EXHIBIT A-4

RE: MINOR SITE PLAN APPLICATION

Streamwood Associates/Williamstown, LLC (Madison Court Apartments) 1056 South Black Horse Pike (Block 3601 – Lots 6, 7 and 8)

Please be advised that I have been retained to represent Streamwood Associates/Williamstown, LLC relative to the above referenced site plan application which is currently pending before the Monroe Township Planning Board. I am in receipt of your separate letters dated May 20, 2020 wherein you provide a completeness and technical review of our application materials.

Pinelands Management Area (Regional Growth Area)

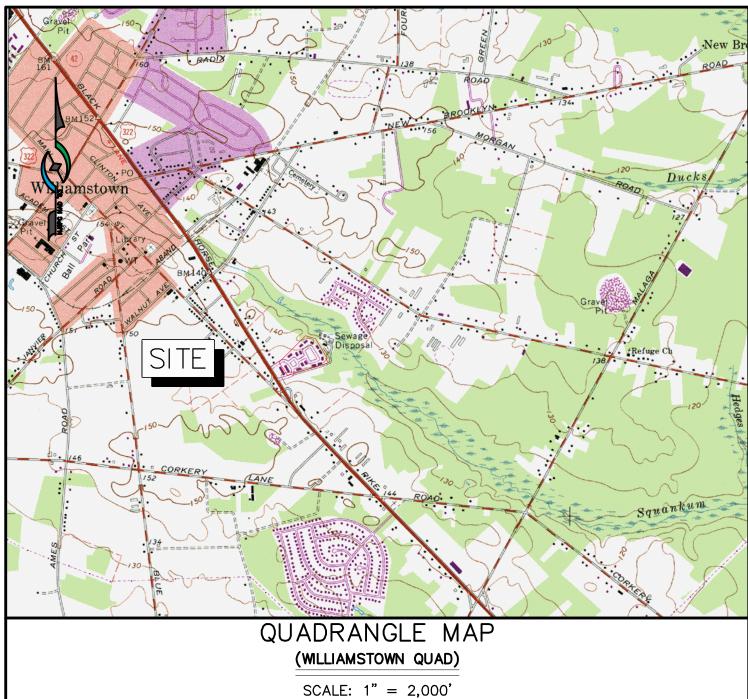
- 1. Attached is the screenshot of the NJDEP GeoWeb showing the Pinelands Management Area. The site is in the Regional Growth Area and a note will be added to the plan to that effect.
- 2. Attached is a plan titled "Existing Conditions Plan, Madison Court Apartments, Block 3601, Lot 7, Township of Monroe, Gloucester County, NJ", Sheet C1801, by Marathon Engineering, dated June 15, 2020 which, likely, satisfy your comments regarding the provision of contours.
- 3. USGS map the USGS is provided on the Existing Conditions Plan. Please advise of you will require that this be added to the site plan.

EXISTING CONDITIONS PLAN

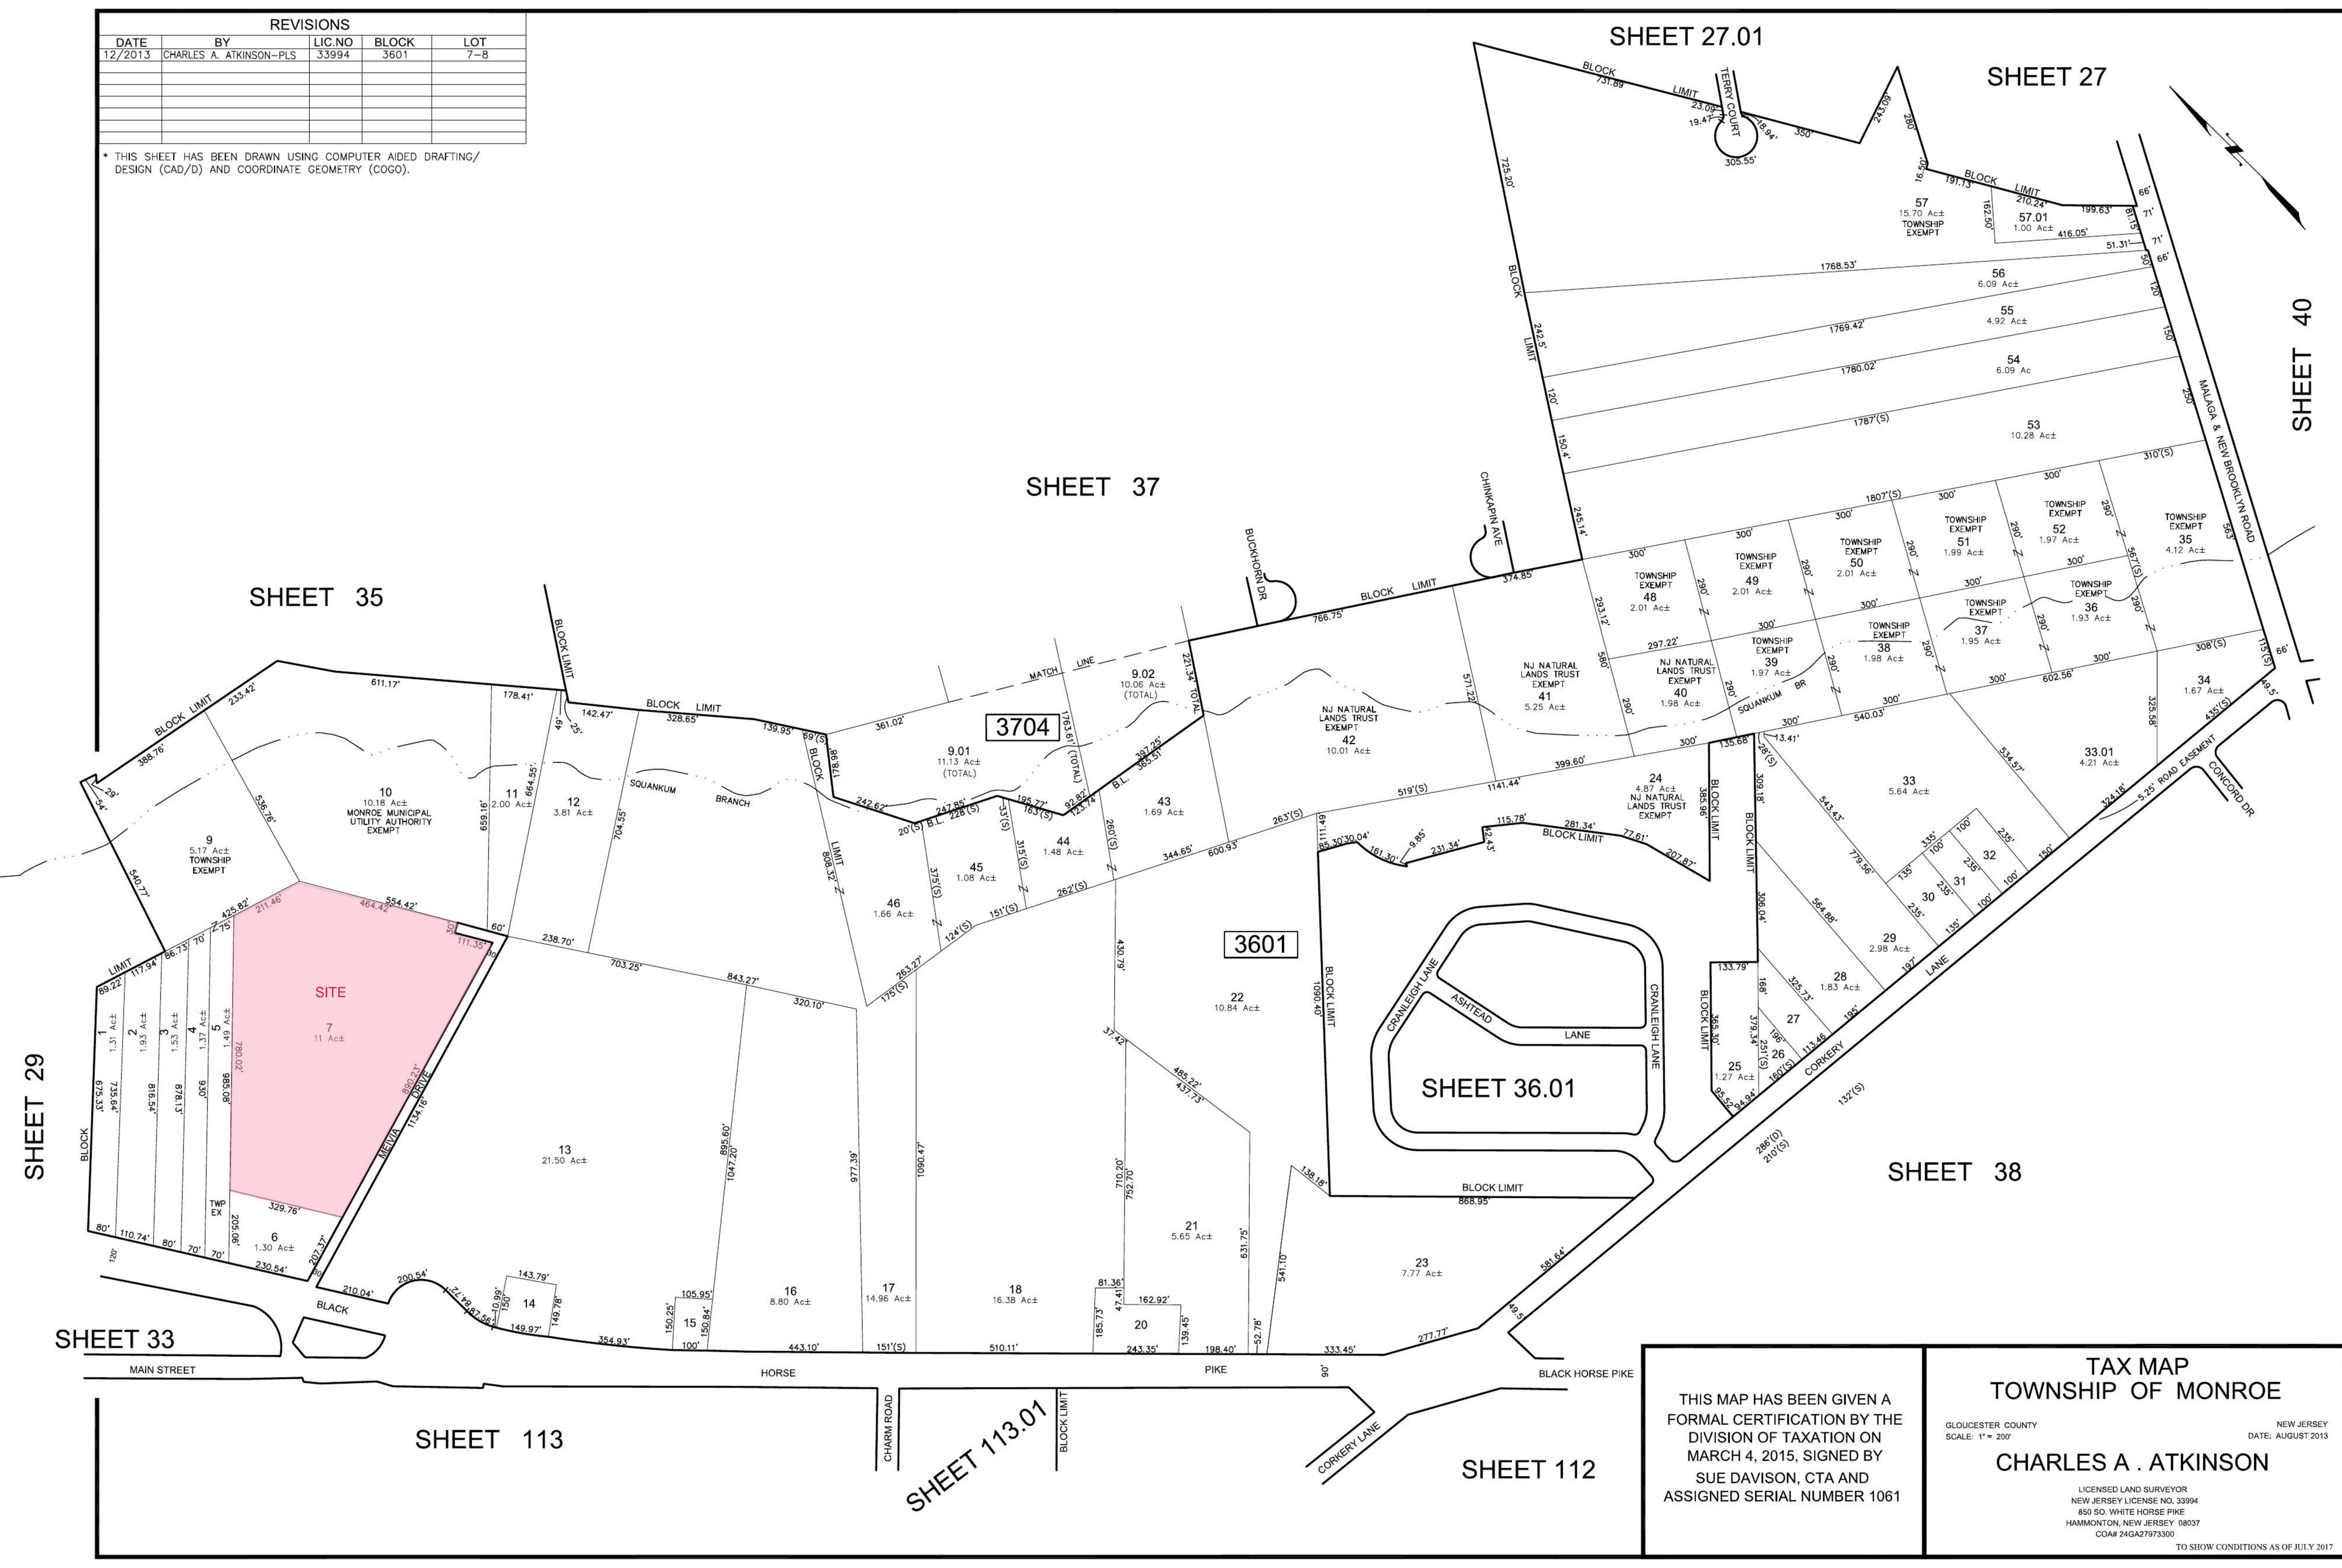
- 4. Tax Map A tax map was included in the original application and a copy is attached hereto.
- 5. Soils Map the Web Soil Survey is attached. The site is located in soils that are rates HSG-A.
- 6. Existing contours these are shown on the Existing Conditions Map (based on NOAA Lidar data).
- 7. Proposed contours none are proposed the contractor will match ex grades and provide a 2% slope in the proposed parking area.
- 8. Drainage patterns/flow arrows drainage patterns in the parking area can be seen by the contours in the Existing Conditions Plan.
- 9. Drainage discharge point The onsite drainage discharges to the swale located along the south/eastern portion of the property. The swale can be seen on the Existing Conditions Plan.
